# PRELIMINARY AND FINAL DRAINAGE PLAN AND REPORT

## FALCON STORAGE SUBDIVISION

PCD File No. PPR2232  
PCD File No. MS232

SUBJECT: Preliminary and Final Drainage Plan and Report  
Falcon Storage Subdivision

FALCON STORAGE SUBDIVISION  
LATIGO BUSINESS CENTER  
DRAINAGE OUTFALL POINT  
NTS

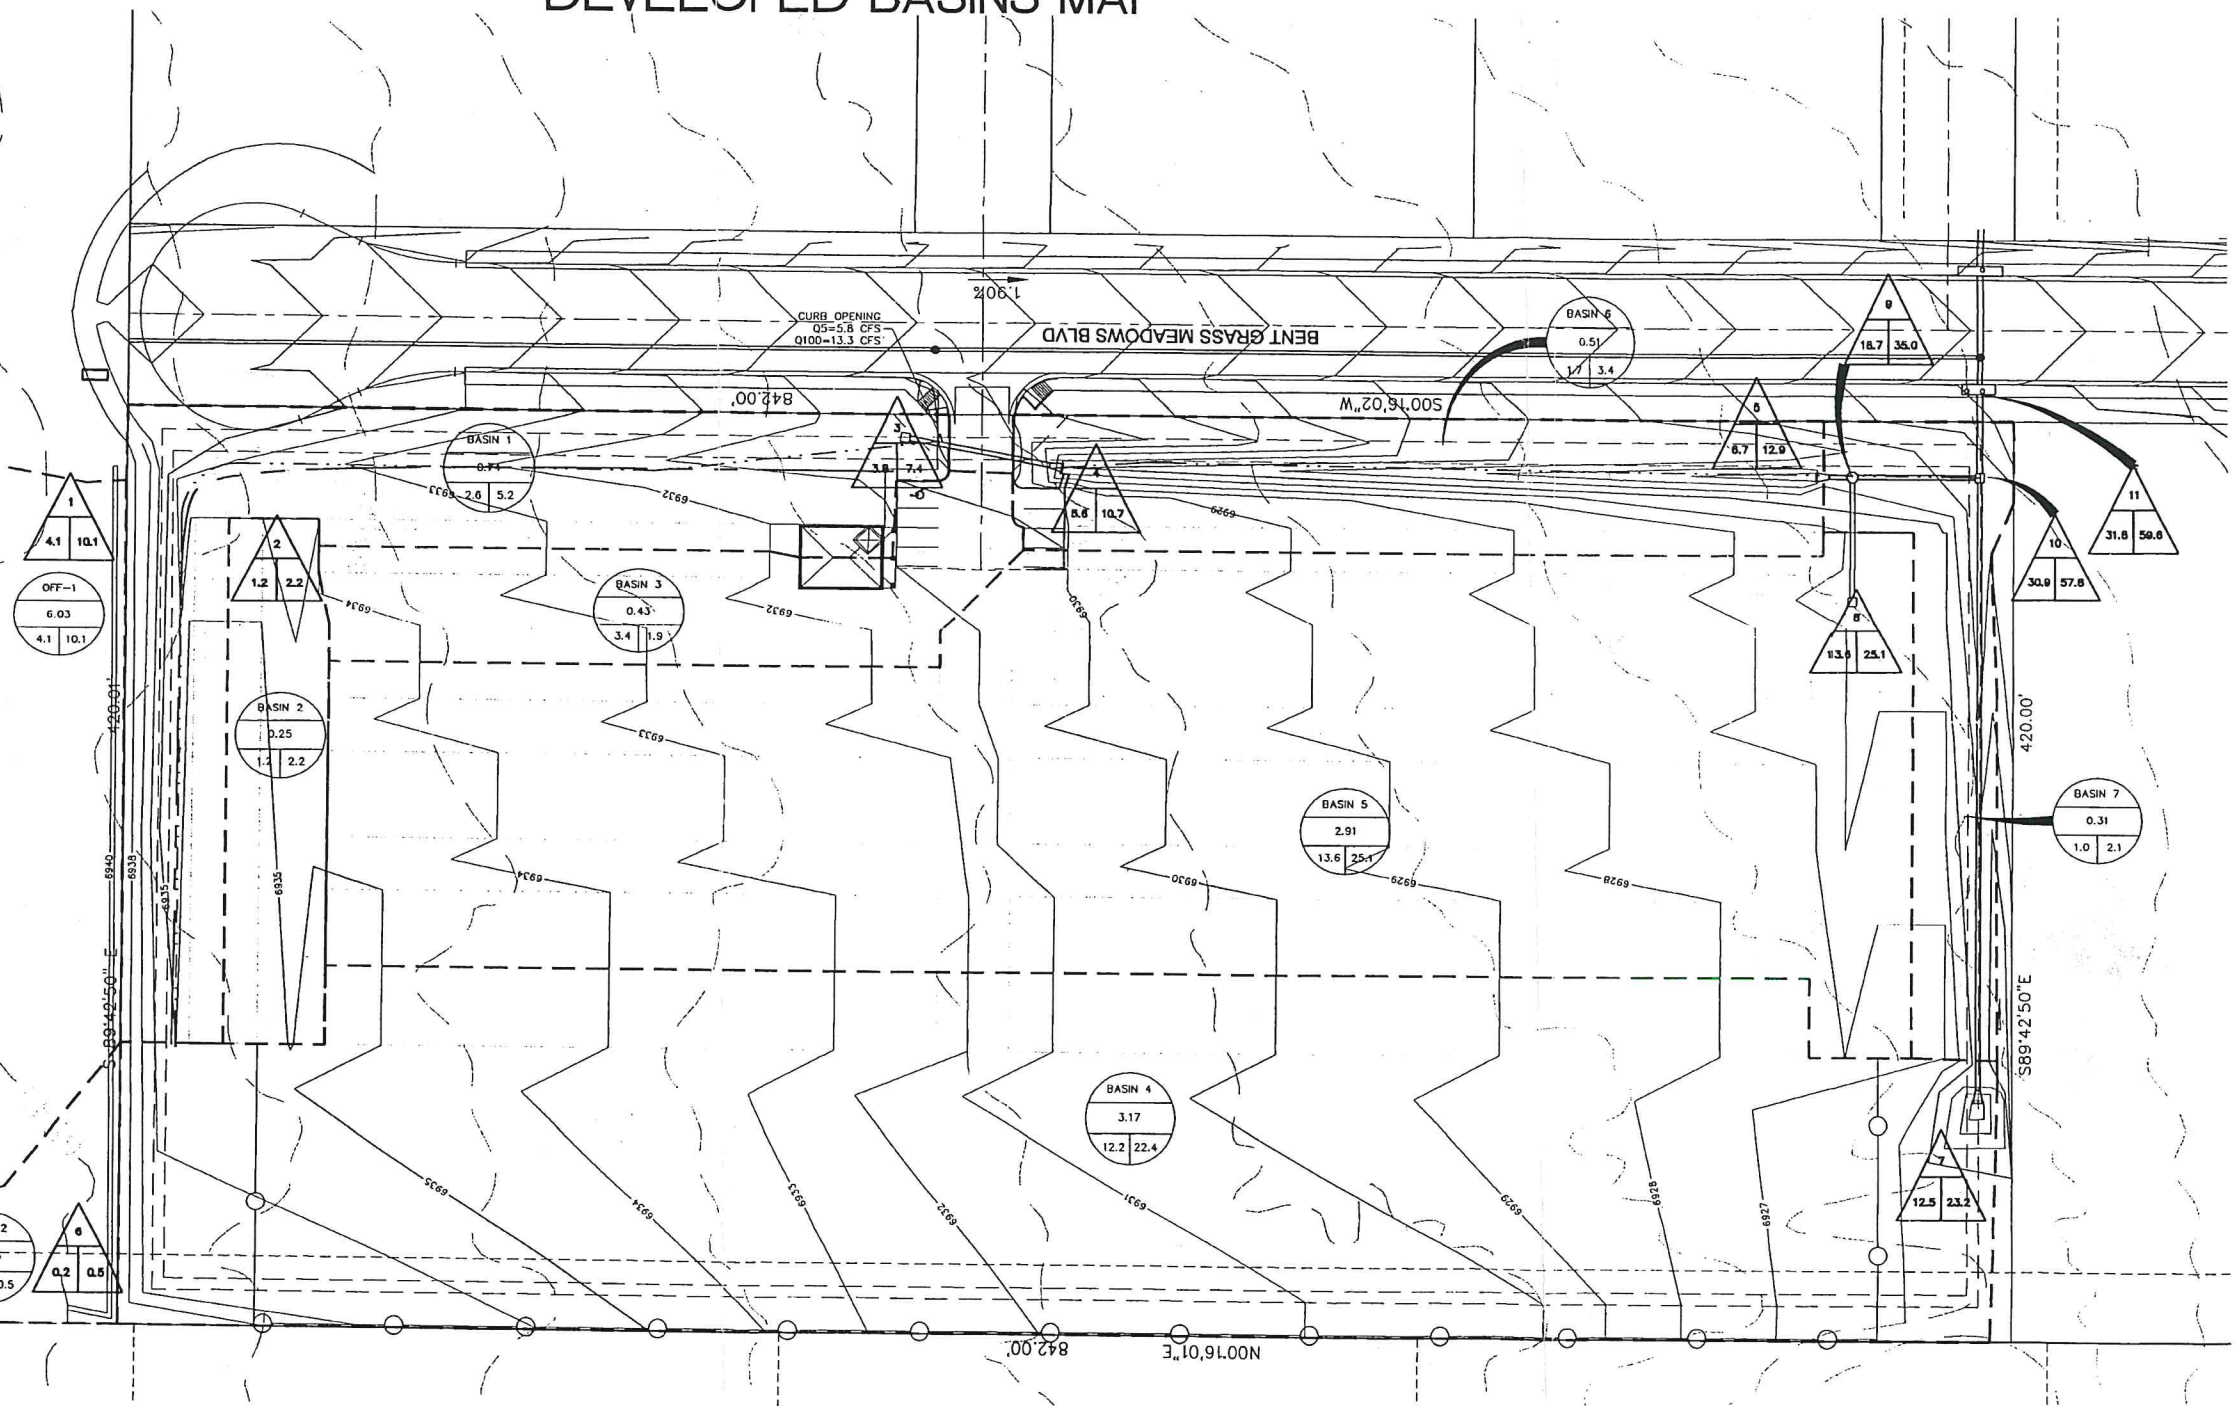
analyze the facilities  
along the  
downstream  
conveyance path and  
show and state in the  
narrative whether  
they are adequate  
and/or any necessary  
improvements.

FALCON STORAGE SUBDIVISION  
LATIGO BUSINESS CENTER, LOT 1  
DRAINAGE PLAN  
NTS

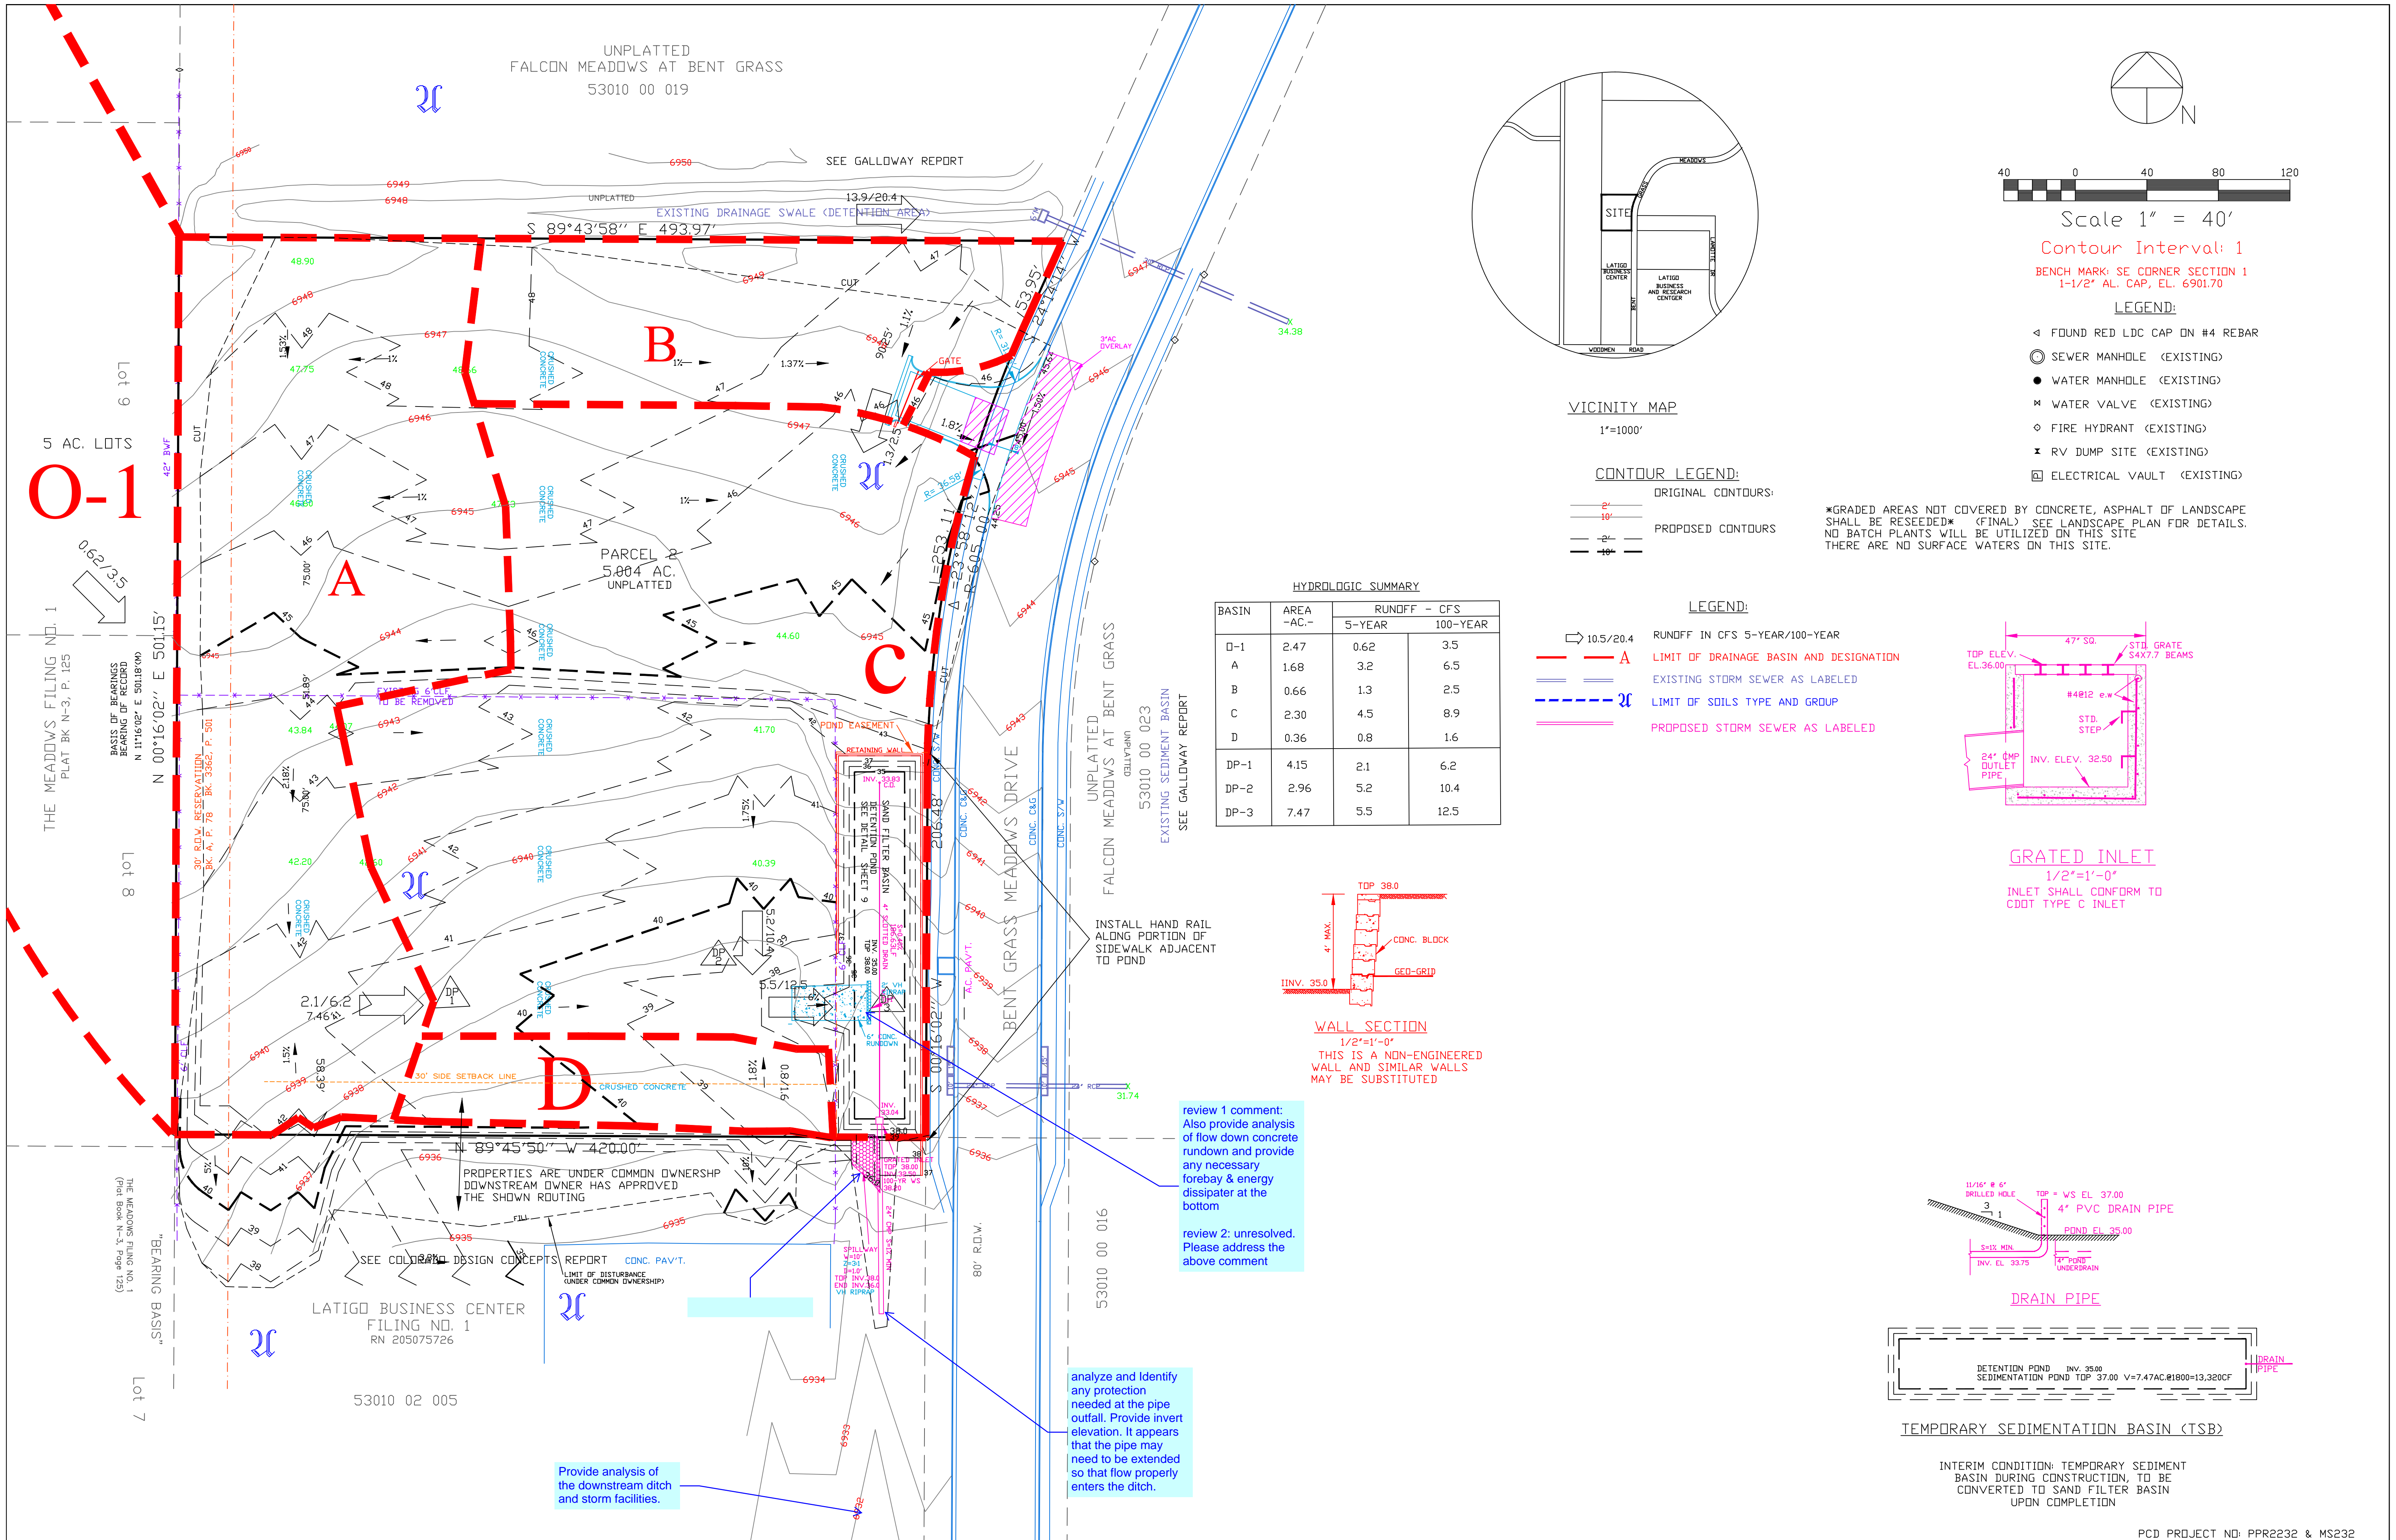
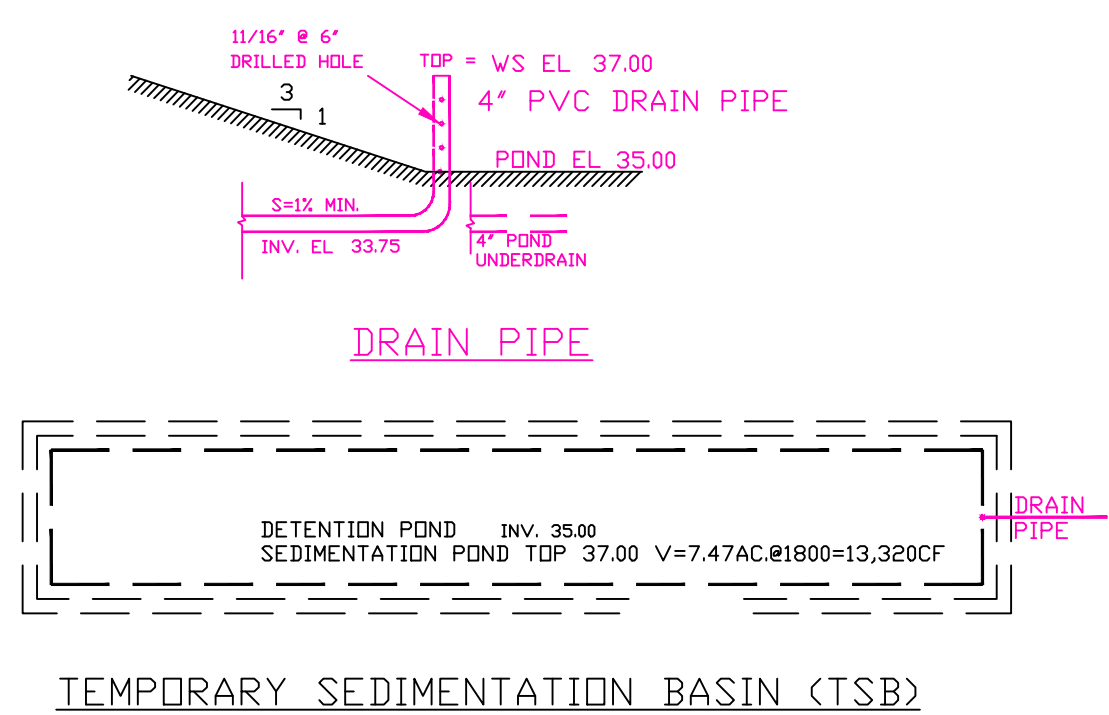
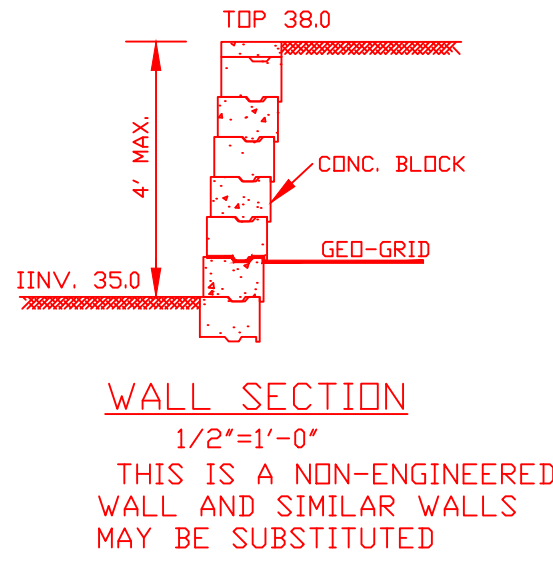
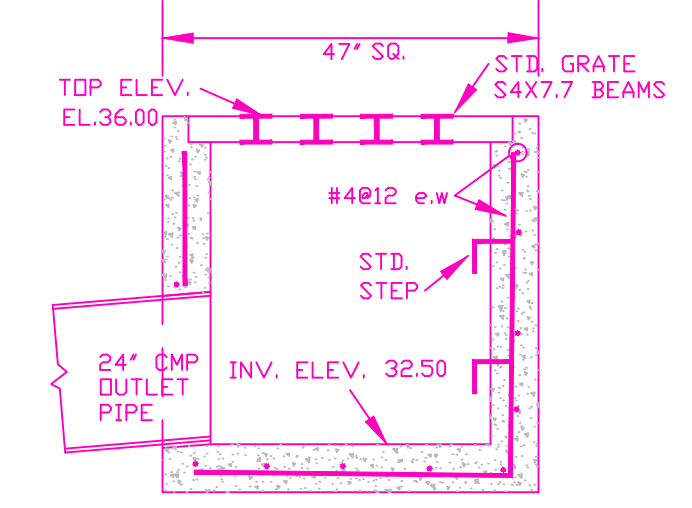
review 1 comment:  
Also provide analysis of flow down concrete rundown and provide any necessary forebay & energy dissipater at the bottom

review 2: unresolved.  
Please address the above comment

analyze and identify any protection needed at the pipe outfall. Provide invert elevation. It appears that the pipe may need to be extended so that flow properly enters the ditch.

Provide analysis of the downstream ditch and storm facilities.
